2009 ADDENDUM TO THE
ENVIRONMENTAL IMPACT REPORT

San Quentin State Prison Condemned Inmate Complex Project

State Clearinghouse Number 2003122003

June 26, 2009

Comparison of 2007 and 2009 Addendum Site Plans

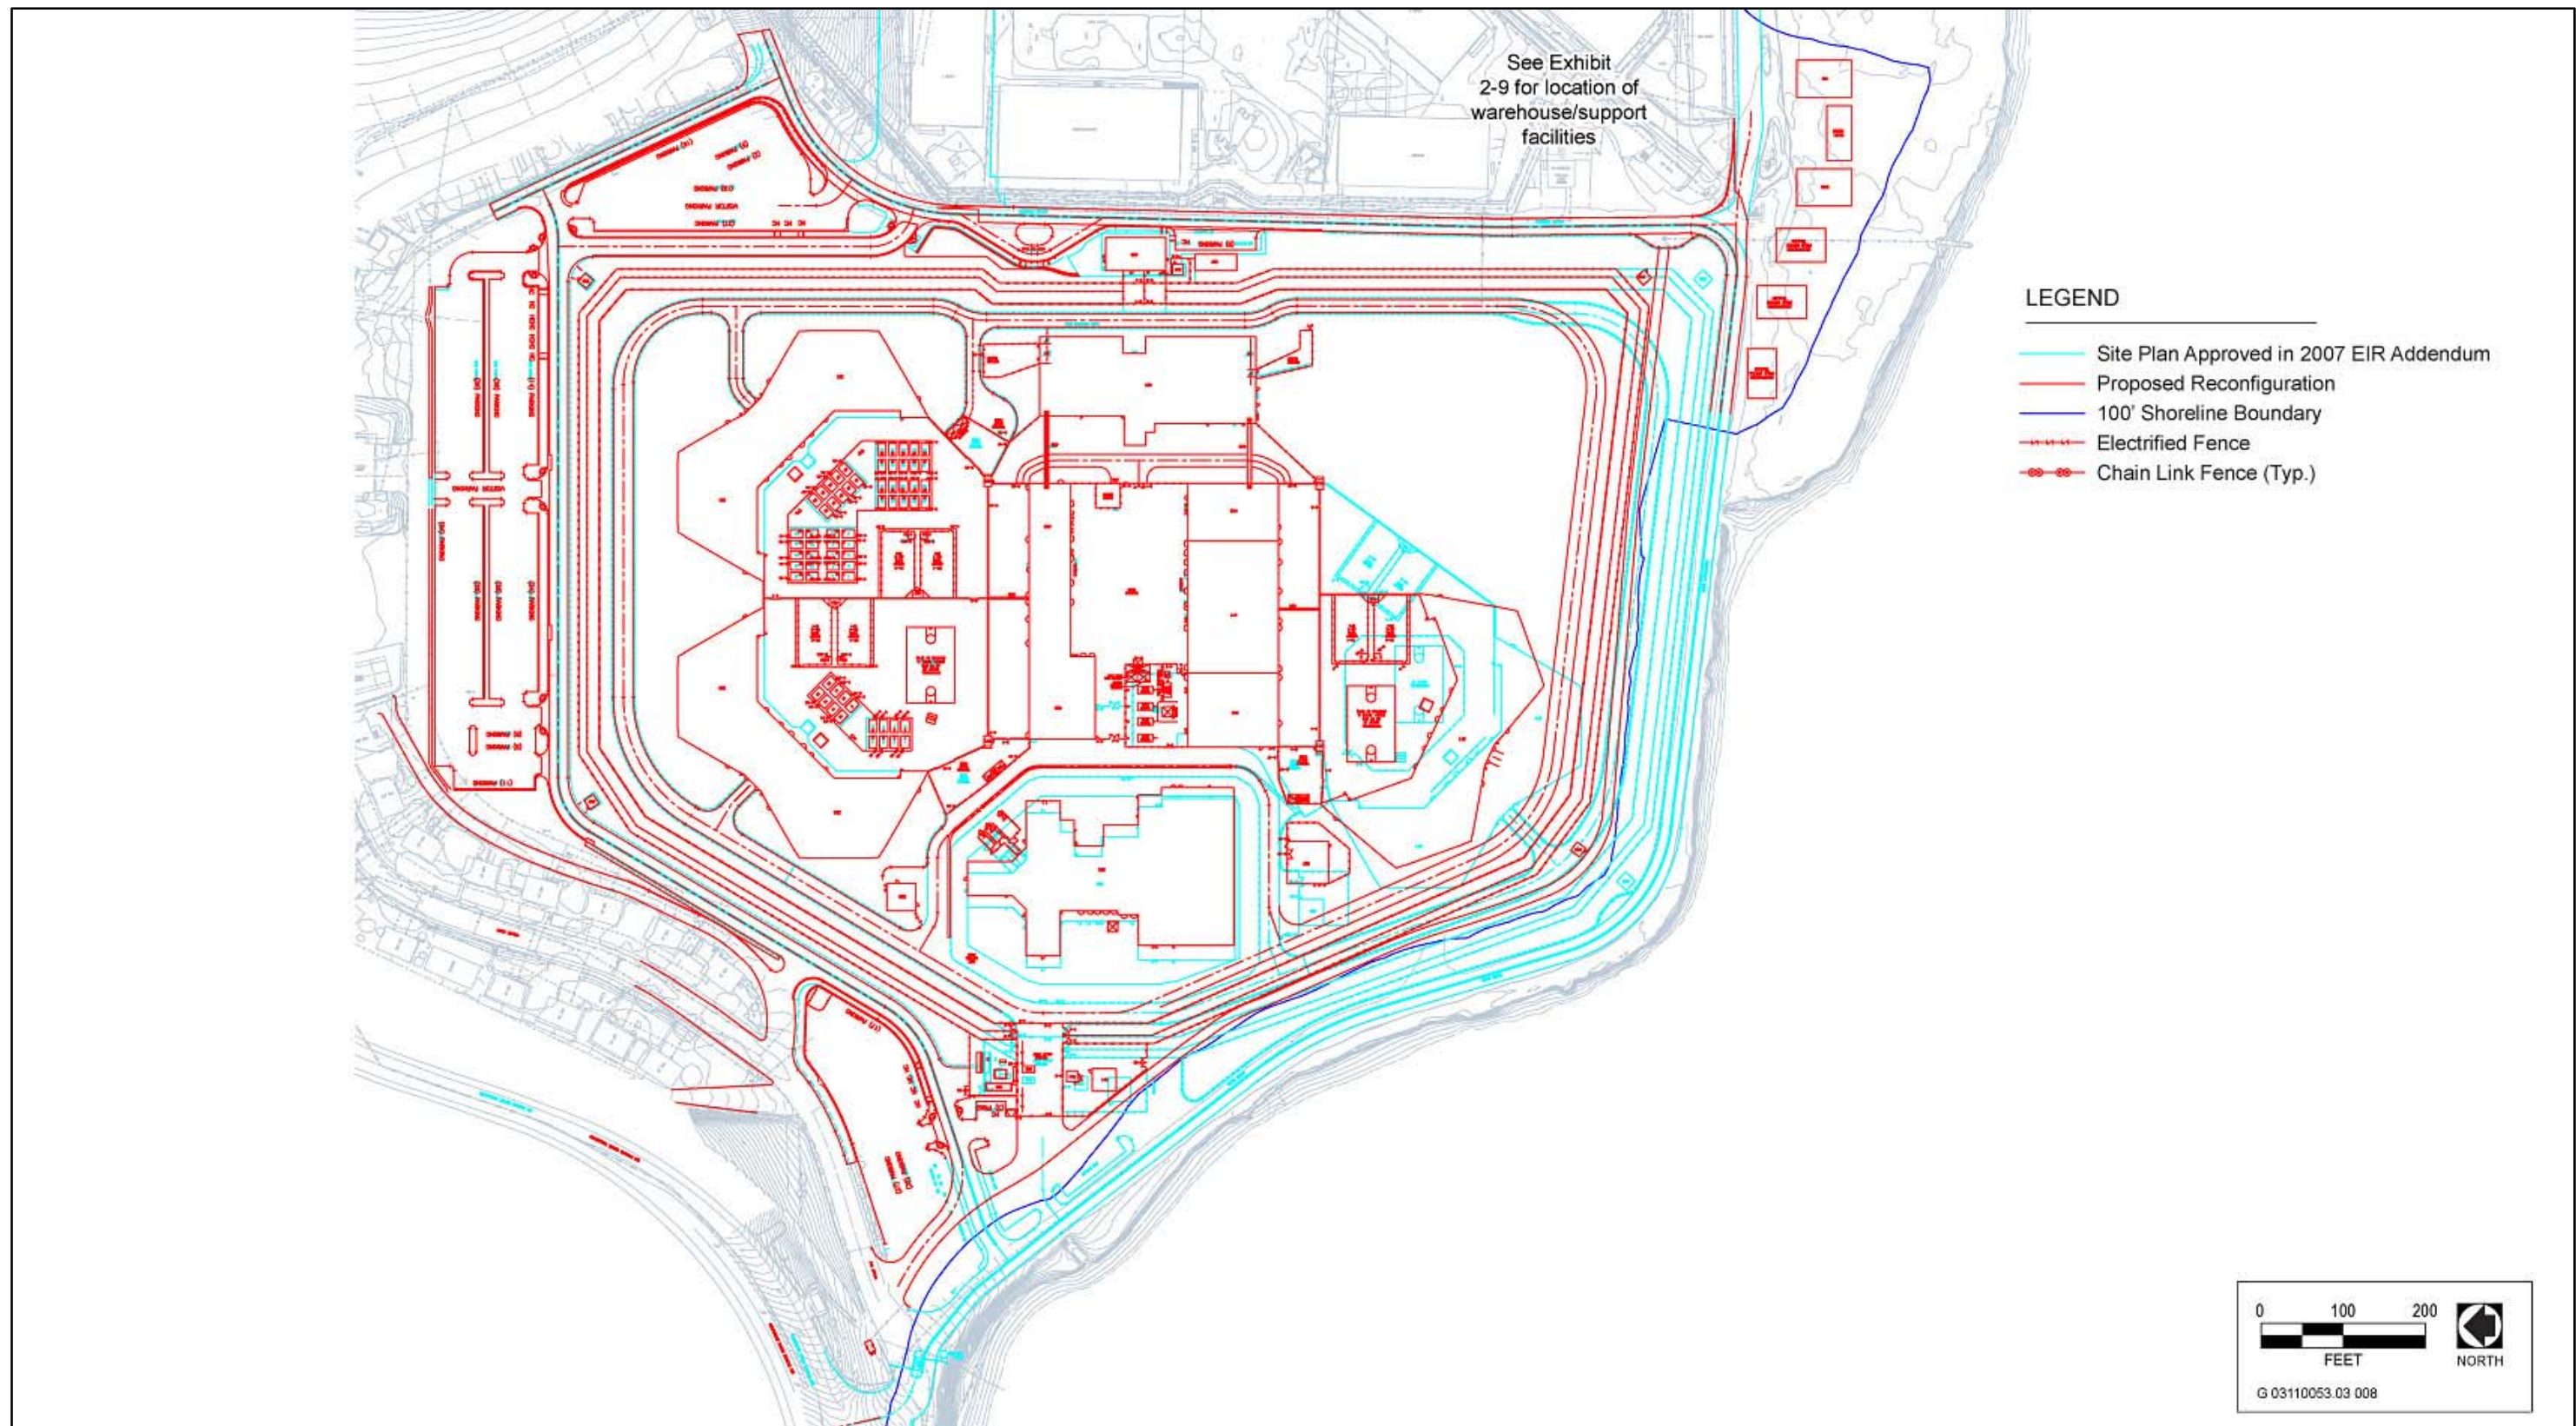
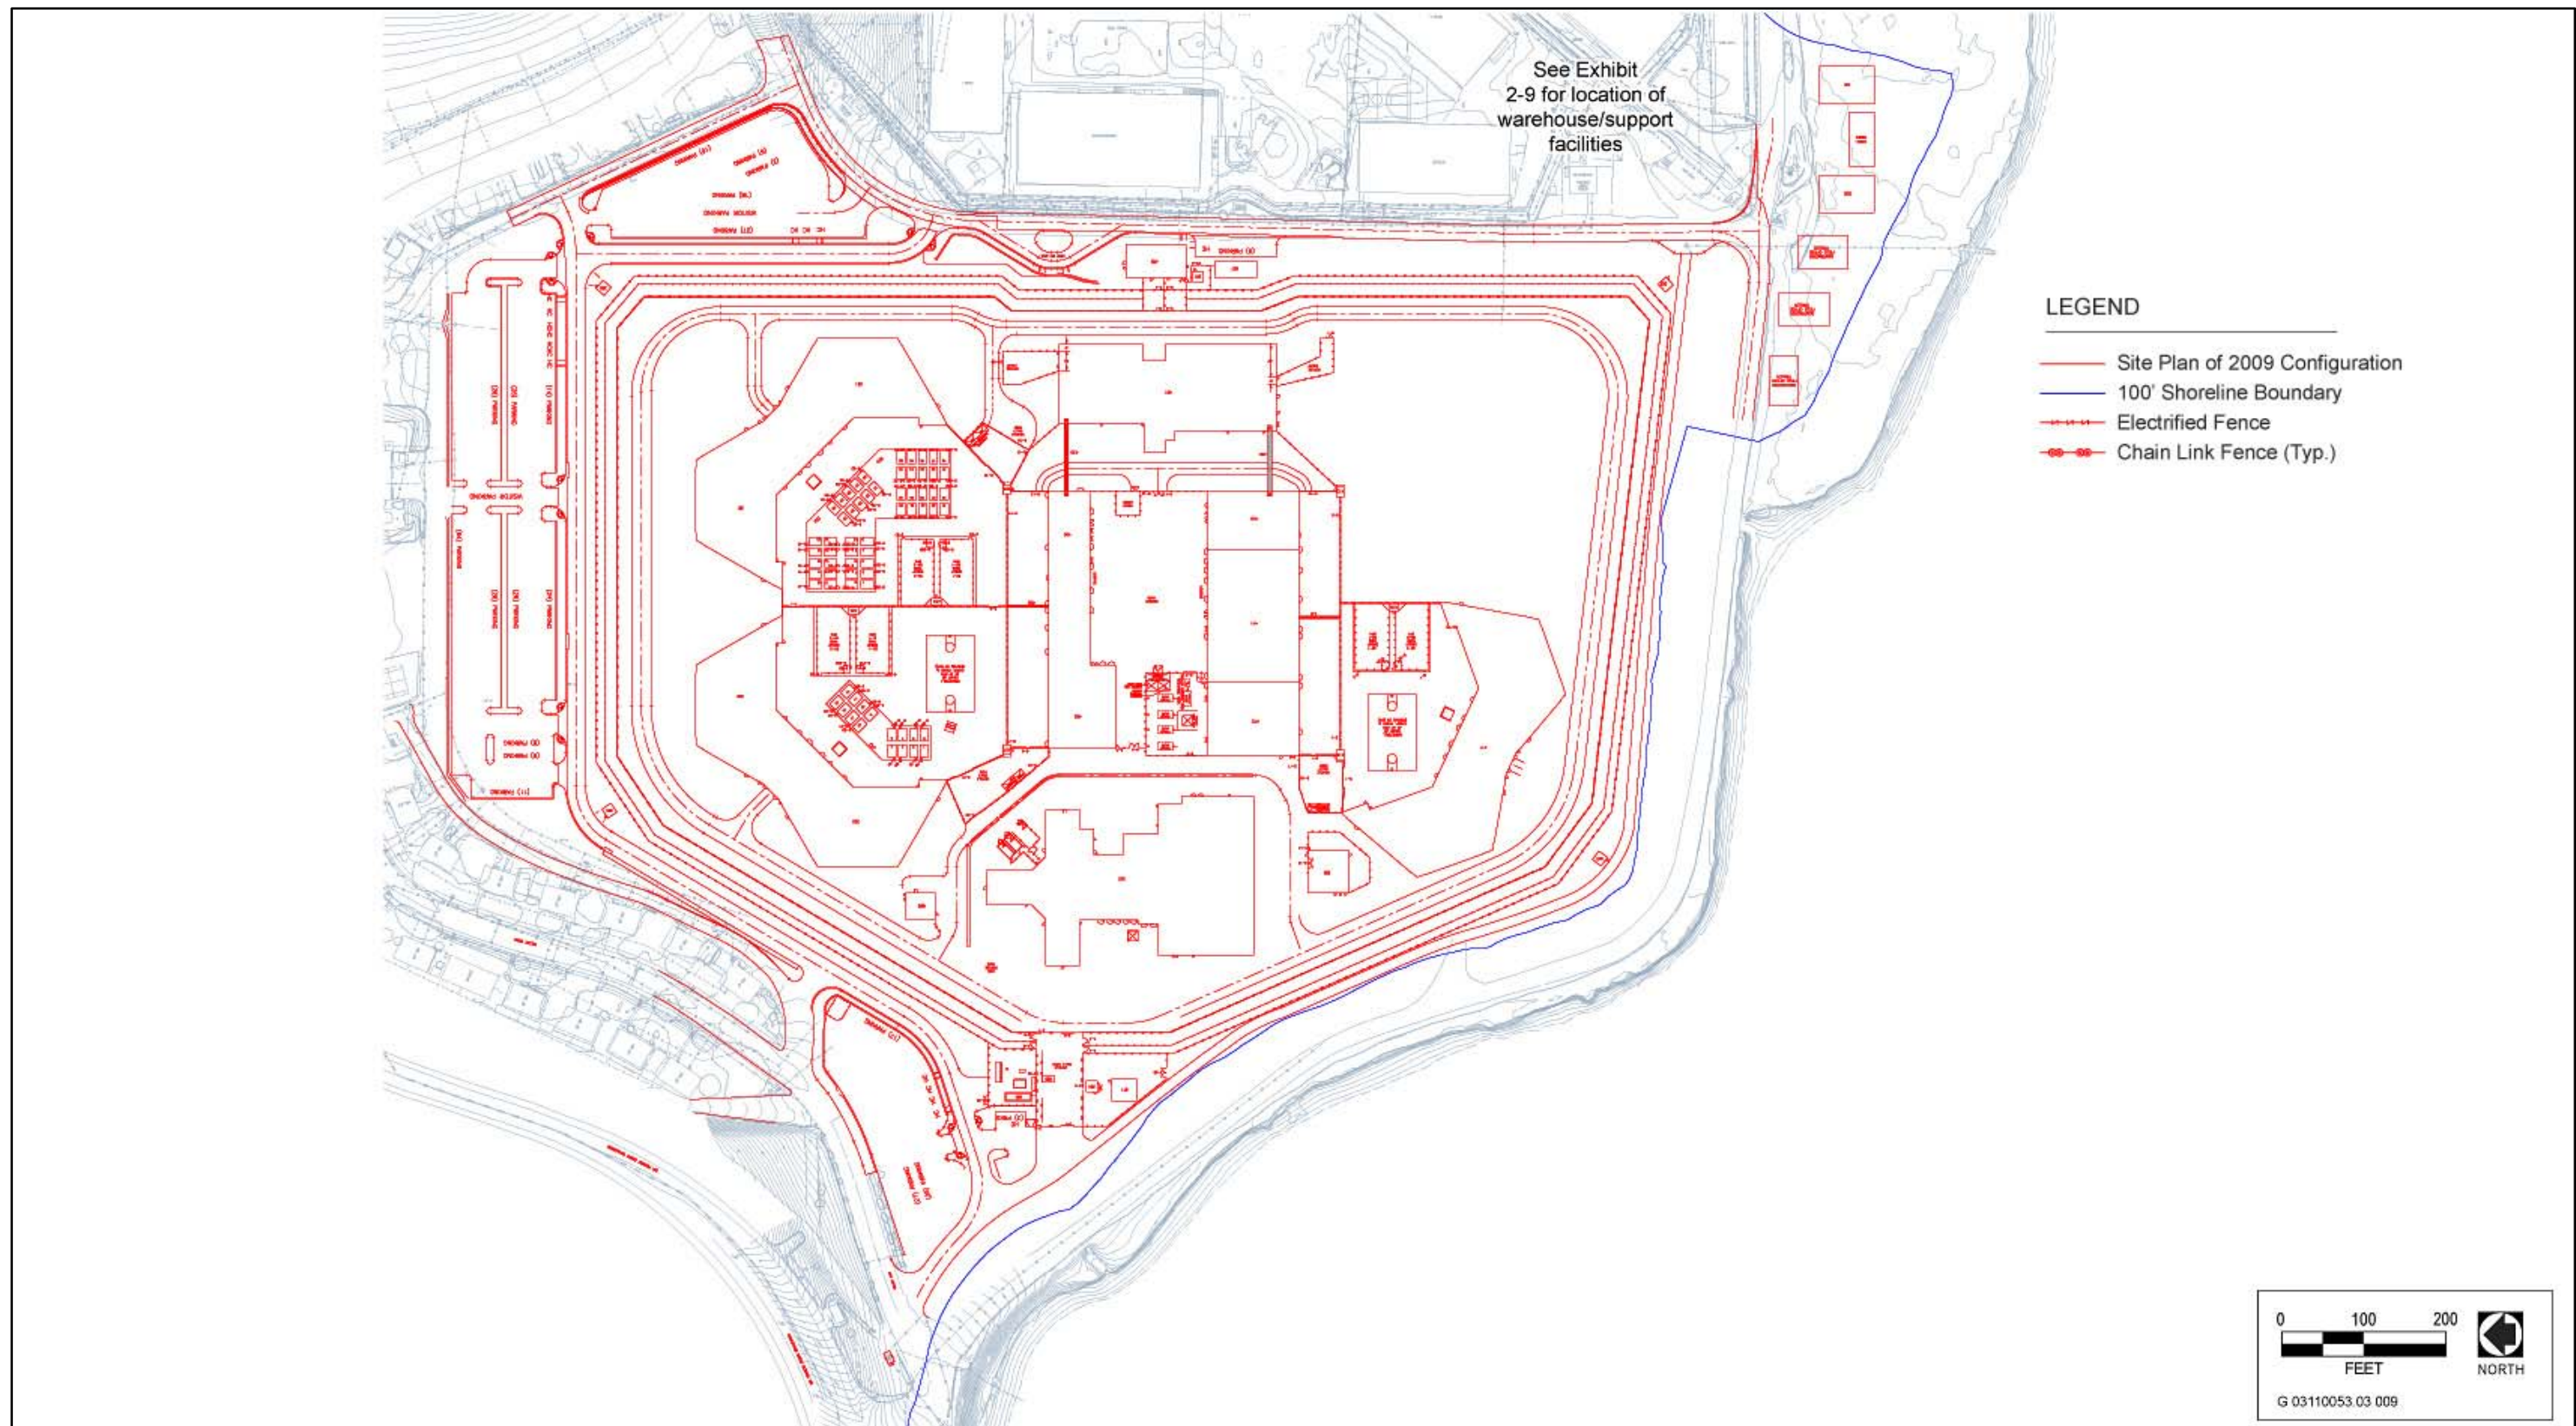
1. A small portion of the proposed security perimeter fence, including lethal electrified fence, within the BCDC shoreline zone would be moved outside of this zone. Refer to Exhibit 2-7 for realigned site plan, including new location of security perimeter fencing and towers.

2. One proposed CIC inmate housing unit would be shifted to accommodate realignment of the perimeter fence and other project improvements so as to avoid the BCDC shoreline zone. There would be no change from the approved 2007 CIC site plan related to proposed building square footage, its basic location or maximum inmate cell capacity. Refer to Exhibit 2-7 and Exhibit 2-8 for proposed changes to orientation of CIC buildings.

- A guard tower that was proposed within the BCDC shoreline zone and another guard tower that was proposed outside the perimeter fence of the eastern boundary of the 2007 CIC site plan would be shifted inside the revised boundary of the project.

The proposed realignment and consolidation of the 2007 CIC site plan would result in shifting the proposed CIC security perimeter fence and one guard tower approximately 100 feet back from the shoreline (Exhibit 2-7). By this realignment, no element of the 2007 CIC site plan would encroach within the BCDC shoreline zone. Realignment of the perimeter fence would also result in the need to slightly modify the position of one inmate housing unit to accommodate the new orientation of the fence and guard tower. However, the shift in the orientation of the inmate building and guard tower would be so minor that there would not be a noticeable visual change in comparison to the project evaluated in the EIR. The buildings within the CIC project area would remain in either their exact location or in the case of one inmate housing unit, a slightly reoriented location, so the same mass will be present as was previously analyzed and approved in the earlier environmental documents.
